Sea Link

Volume 9: Examination Submissions

Document 9.86 Applicant's Comments on Other Submissions Received at Deadlines 3 and 3A

Planning Inspectorate Reference: EN20026

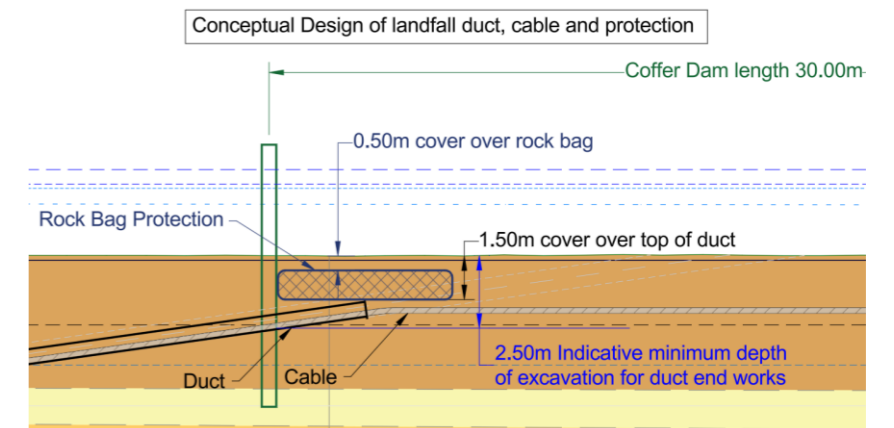
9 9 4.2.15	Natural England notes that post-installation protection will be added to stabilise the HDD exits and the top of this protection would be approx. 0.5m below the seabed. However, in [REP1-103] it is stated that at the Kent landfall, a target depth of lowering of 1.5 m will apply to allow for the potential future lowering of the	With regards to cable protection within the shallow nearshore and intertidal waters of Pegwell Bay, Natural England's default advice is for there to be no cable protection placement within the 10m depth contour. We, therefore, advise that this should be secured as a condition.	Please see response to point 4 on Natural England's Advice On: Application Document 9.20.2 Landfall Sediment Modelling Report Pegwell Bay [PDA-038] above which summarises the Applicants position on the likely future morphological changes in Pegwell Bay. As noted in the detailed landfall assessment, Application Document 9.20.2 Landfall Sediment Modelling Report

intertidal bed levels. This would suggest that the depth of HDD exit protection burial would not be sufficient to allow for potential future lowering of the intertidal bed levels. This needs to be clarified.

This technical note does not provide details of any other requirements for protection of buried assets within Pegwell Bay. However, owing to potential impacts to marine physical processes and sensitive habitats within the nearshore and inter-tidal areas where the cables make landfall, our standard advice is for there to be no cable protection within the 10m depth contour.

We advise that further information and clarification is needed to demonstrate the adequacy of HDD exit protection depth relative to future lowering of the intertidal bed levels.

The final solution will be subject to the Contractor's detailed design and methods engineering. As described in **Application Document 9.13: Pegwell Bay Construction Method Technical Note [REP2-011]**, post-installation protection such as rock bags/concrete mattresses may be added to stabilize the HDD exits (proximal intertidal section), replacing the existing temporary protection. This protection would be buried 0.5m below existing seabed level. The illustrative scenario described in the Technical Note describes the location of the top of the duct approximately 1.1 m below the seabed and the top of the rock bags/mattresses laid on top of the duct as approximately 0.5 m below the seabed.

The figure below provides an indicative arrangement for the HDD exit and protection in the long term. The primary function of the protection is to ensure safe excavation of the duct end if the cable needs to be replaced in the future. Rock bags are the base case protection. As with the cable through the intertidal area, the HDD exit location will be monitored for scouring / exposure in the long term and can be reburied at a deeper depth if required, noting that the 0.5m depth to the top of protection shown is deeper than variations in seabed level for the upper to mid zone identified in **Application Document 9.20.2 Landfall Sediment Modelling Report Pegwell Bay [PDA-038]**.

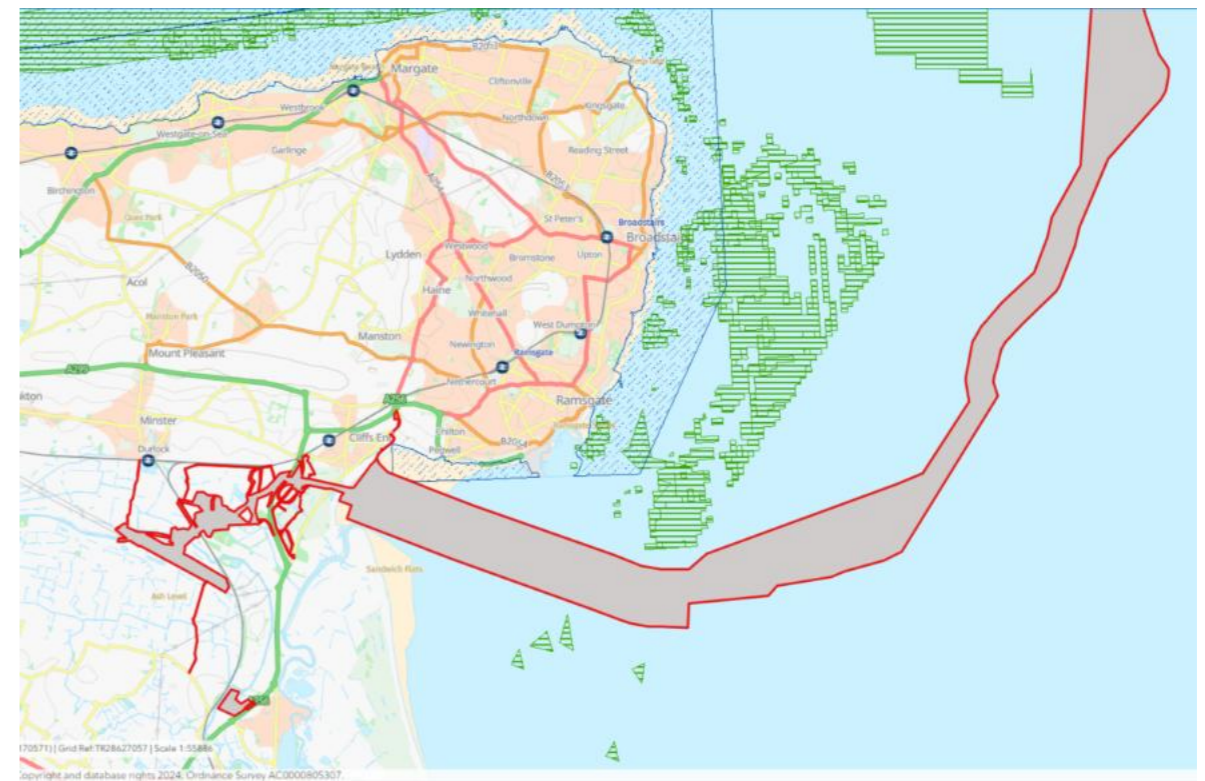
Natural England notes that there are potential cable burial issues due to bedrock (chalk) which are not clearly presented or discussed in the CBRA, particularly around KP 96 -KP 117. We highlight that this area is close to Goodwin Sands and to the southwest towards the approaches of Pegwell Bay. We therefore highlight that if there is insufficient burial depth here and a need for cable protection then it may affect the sediment transport pathways/processes around here and the benthic receptors of the designated sites.

We also highlight that in [CR1 – 009] that areas of potential chalk also align with the widest cable corridor.

Natural England advises that impacts to Goodwin Sands MCZ and coastal designated sites from indirect impacts from the placement of cable protection and potential disruption of marine/coastal processes requires further consideration.

Furthermore, the Applicant has already taken steps at the project design stage to avoid routing through any sites that are designated for benthic and sediment features, further reducing the potential for any impacts on these sites and associated protected features of these sites.

Appendix Plate A.2 Area of Modelled Exceedance of Thresholds

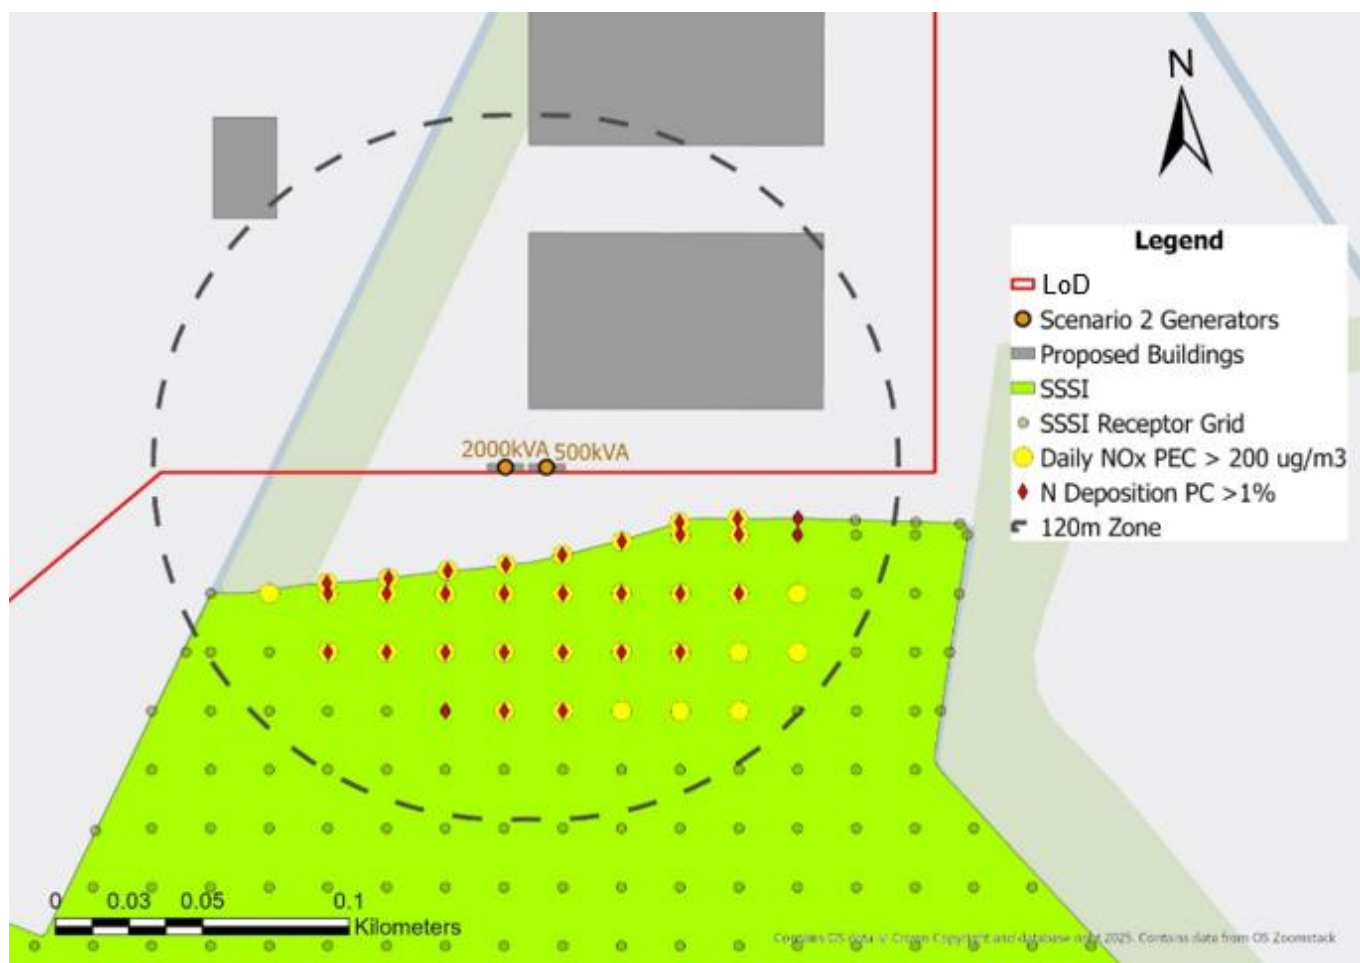
- A.7.48 The results show that if both generators were positioned close to the SSSI then there would be potential for significant air quality effects on the SSSI. The receptor grid for the SSSI has been used to determine how far from the generators there could be potentially significant effects. **Appendix Plate A.2 Area of Modelled Exceedance of Thresholds** shows the grid points where exceedances of the daily mean NO_x critical level are predicted (Daily NO_x PEC > 200 ug/m³), and where the N deposition PC exceeds the 1% critical load for N deposition.

- A.7.49 The results show that the area of potential significant effects extends up to approximately 100 m from the generators, and so if the generators were positioned at least 120 m from the SSSI, there should be no significant effects. A 120 m zone around the generators is also presented in **Appendix Plate A.2 Area of Modelled Exceedance of Thresholds**, to help demonstrate this, as it shows there are no threshold exceedances within this area. This is also partly demonstrated by Scenario 1, as both generators are located more than 120 m from the SSSI, and there are no potentially significant effects on the SSSI when considering the thresholds in **Appendix Table A.5 Thresholds for Potential Significant Effects**.

A.7.50 In light of these modelling results, REAC commitment AQ11 (**Application Document 9.84 Register of Environmental Actions and Commitments (REAC) [REP3-078]**) has been updated to ensure backup generators are not placed within 120 m of the SSSI:
